BAR Meeting  
September 7, 2016

**ISSUE:** Replacement Street Lights in the Alexandria Historic Street Light District

**APPLICANT:** City of Alexandria, Department of Project Implementation

Figure 5. Illustration of comparative light color for LEDs at different temperatures. The 2700K represents the warmest light while higher values result in whiter and bluer light.

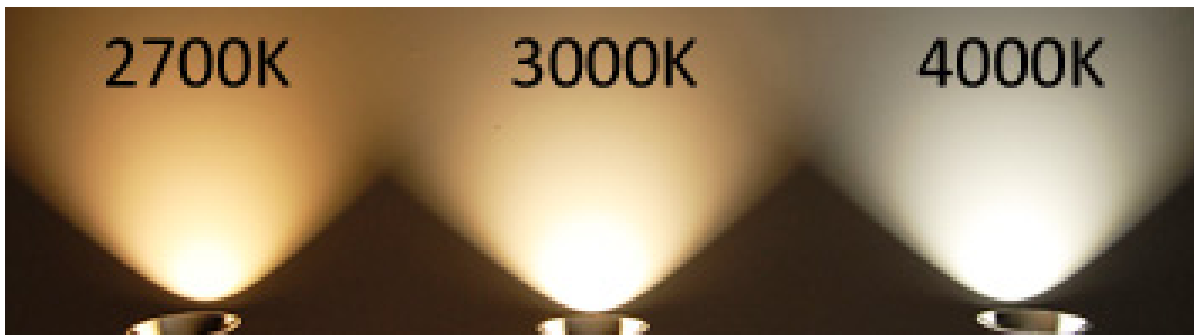
However, the color and character of the illumination is before the BAR. LED technology is continually improving, and it is anticipated that newly available 2700K bulbs would produce a warmer and softer light than the mock-up (see Figure 5) though they are more expensive, use more energy and have a shorter life. Staff recommends that the BAR establish illumination levels and intensity with final approval by BAR staff in the field in order to ensure that the most compatible light color and intensity be employed which also meets public safety requirements.

Staff recommends approval of the new Alexandria Historic Street Light with final light color and ladder bars/banner holders to be approved in the field by BAR staff prior to installation.
